ADDENDUM 1

ALASKA DEPT. OF FAMILY & COMMUNITY SERVICES
JUNEAU PIONEERS HOME
COURTYARD RENOVATIONS
PROJECT NO.: ANC 24-43C

SHEET TITLE:
**DEMOLIITON AND SITE PLANS
ALT 3**

E4.0

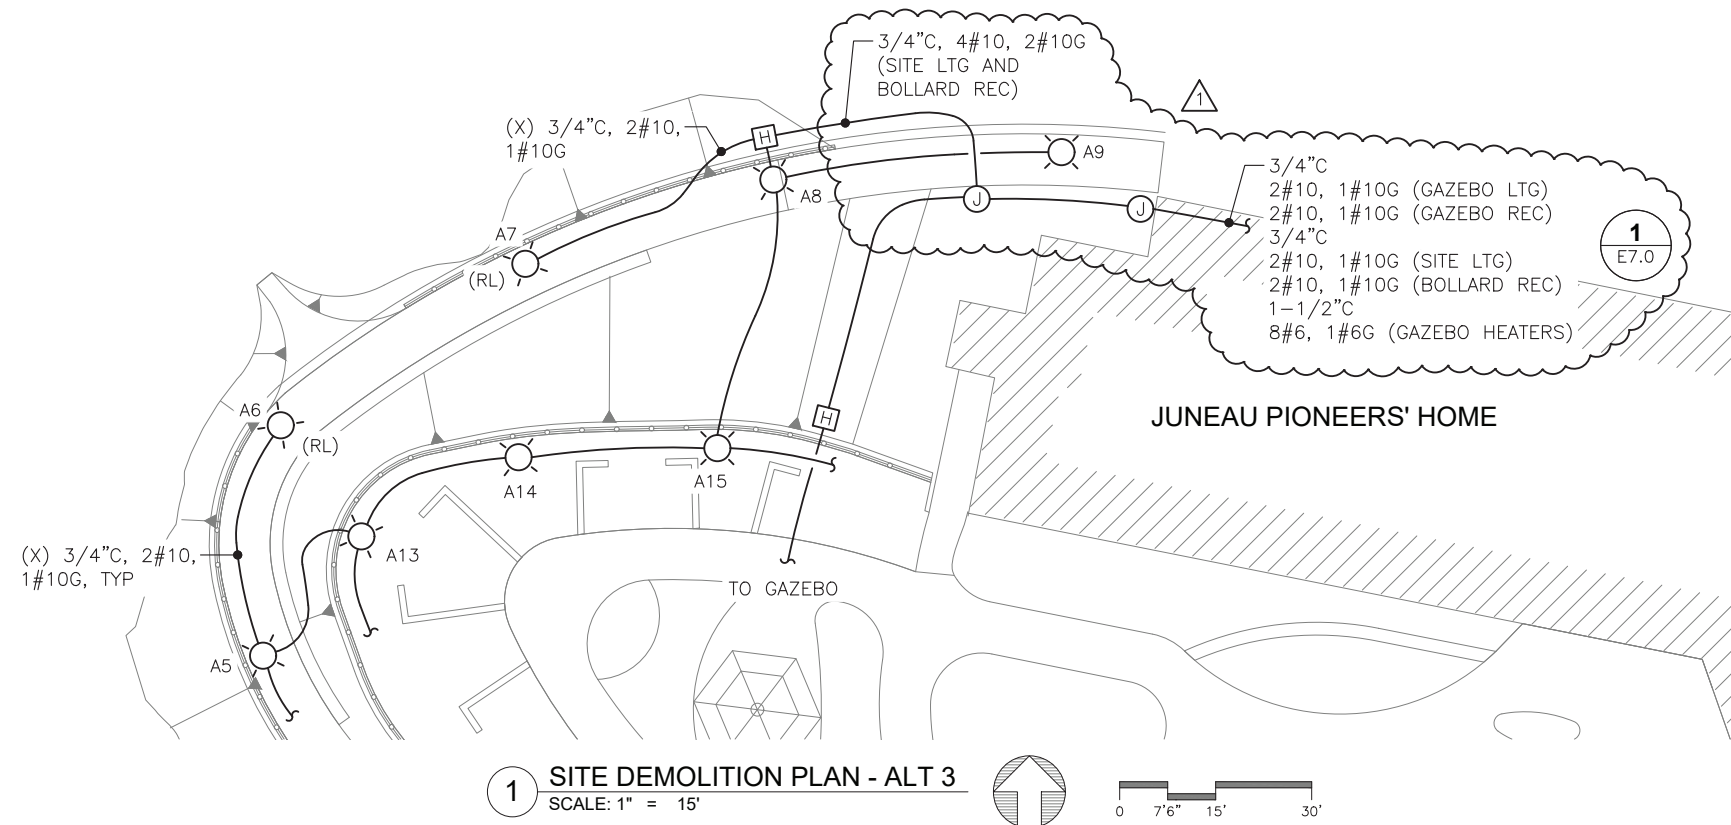
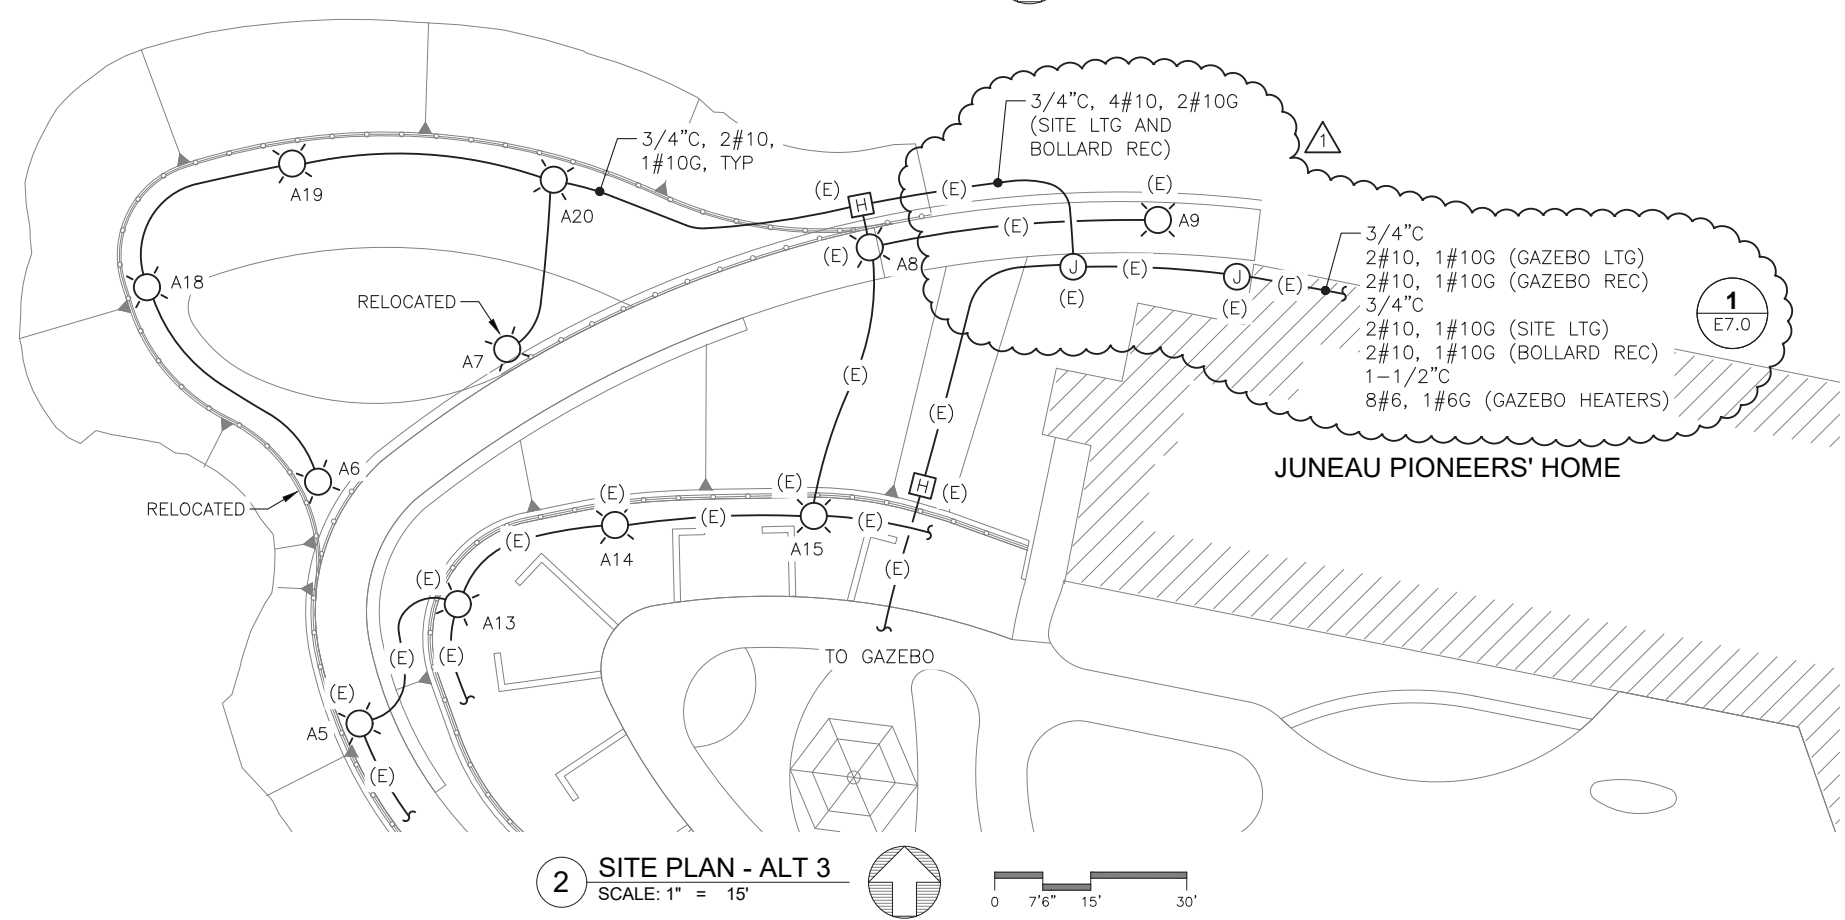
REVISIONS					
REV.	DATE	DESCRIPTION	DWN.	CKD.	APP.
1	6/28/24	REVISE CONDUIT ROUTE AT RETAINING WALL	BJB	BJB	BJB
